CITY OF FORT LAUDERDALE

CASE COMMENT REPORT

CASE NO. UDP-S24061

CASE:	UDP-S24061
MEETING DATE:	November 12, 2024
REQUEST:	Site Plan Level II Review: 1,706 Square-Foot Automotive Repair Station
APPLICANT:	715 Sunrise, LLC.
AGENT:	Kristin DiPierro, Thomas Engineering, Group, LLC.
PROJECT NAME:	Take 5 Oil Change
PROPERTY ADDRESS:	715 W. Sunrise Boulevard
ZONING DISTRICT:	Boulevard Business District (B-1)
LAND USE:	Commercial
COMMISSION DISTRICT:	2 – Steven Glassman
NEIGHBORHOOD ASSOCIATION:	South Middle River Civic Association
CASE PLANNER:	Nicholas Kalargyros

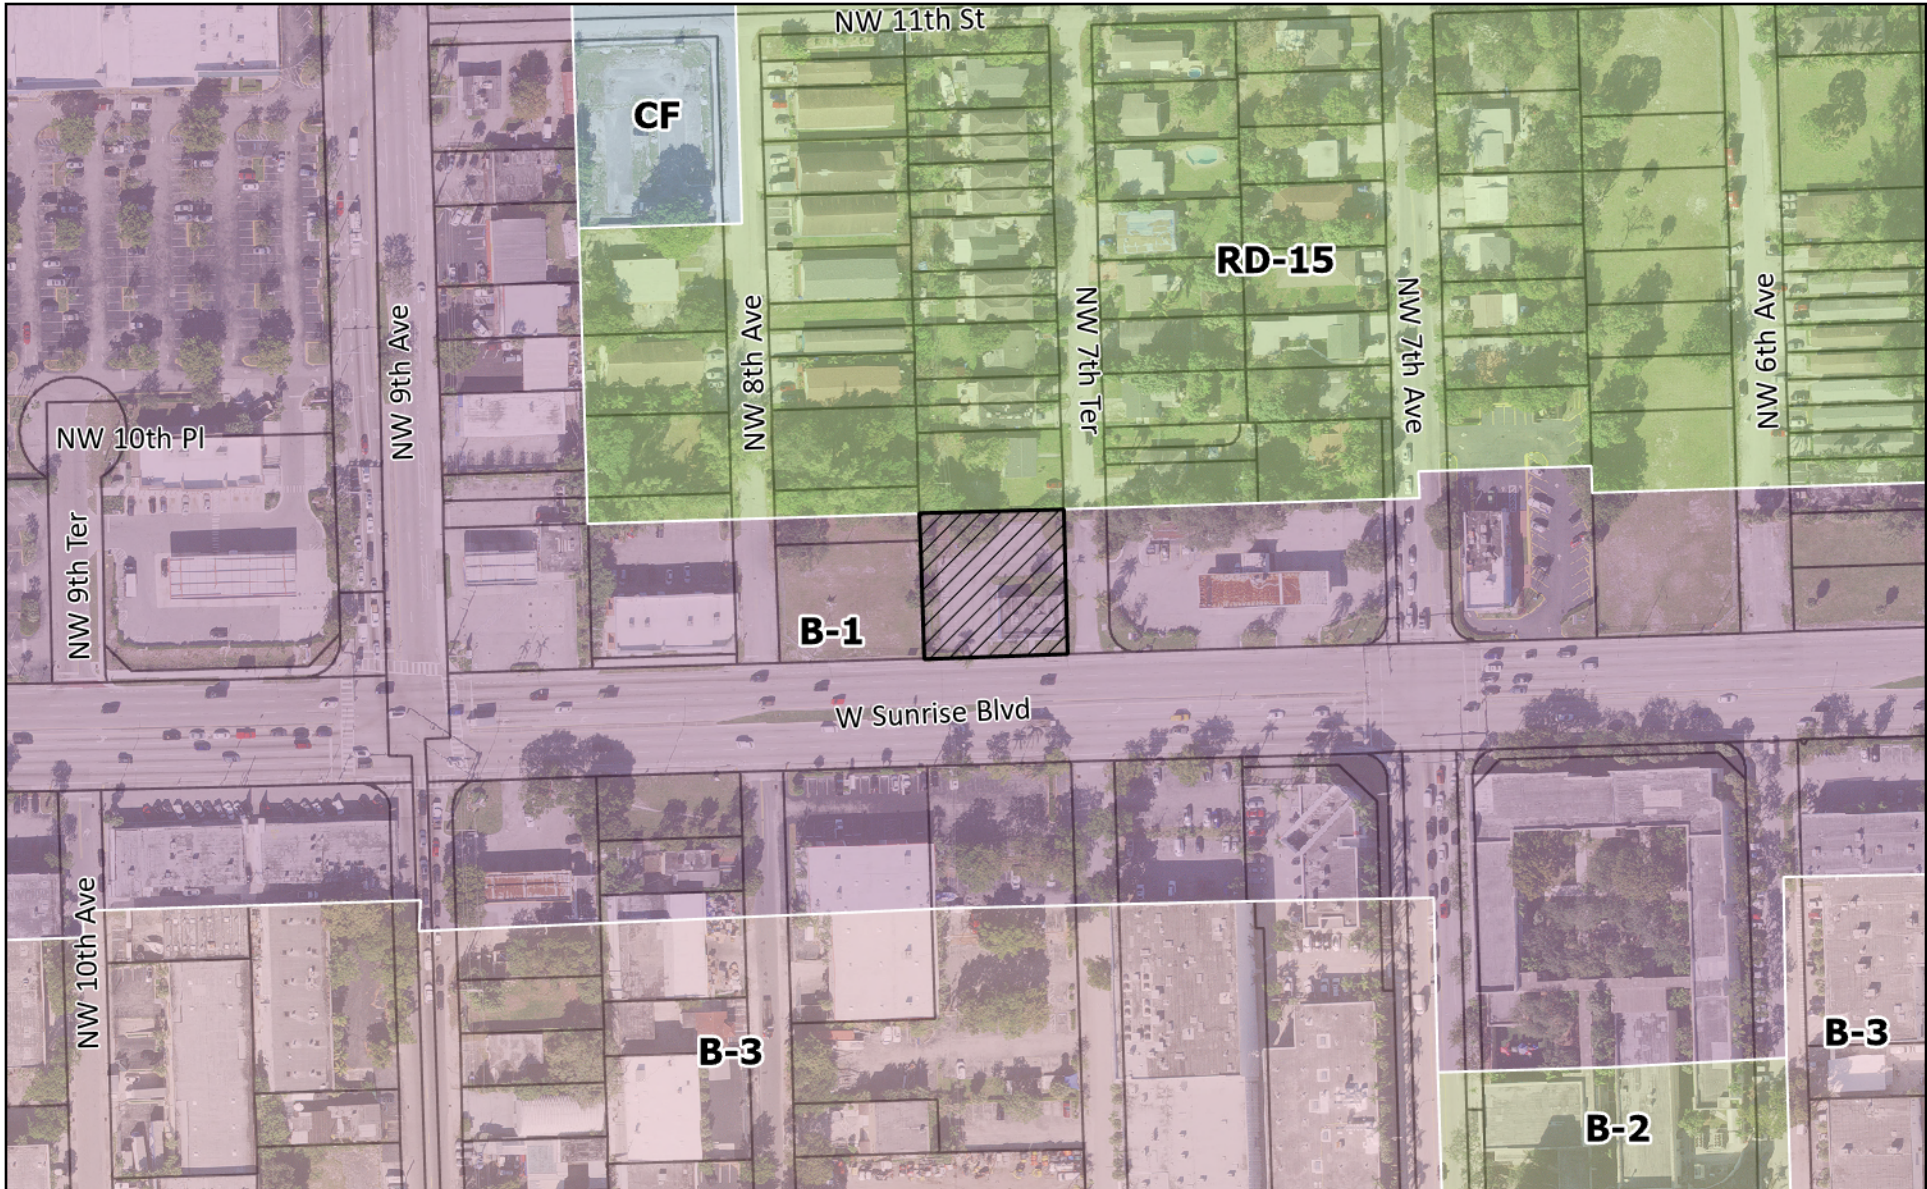
- 9) Other Take-5 Oil locations have enhanced architectural style and design elements that should be incorporated into this project location. The following images are examples.
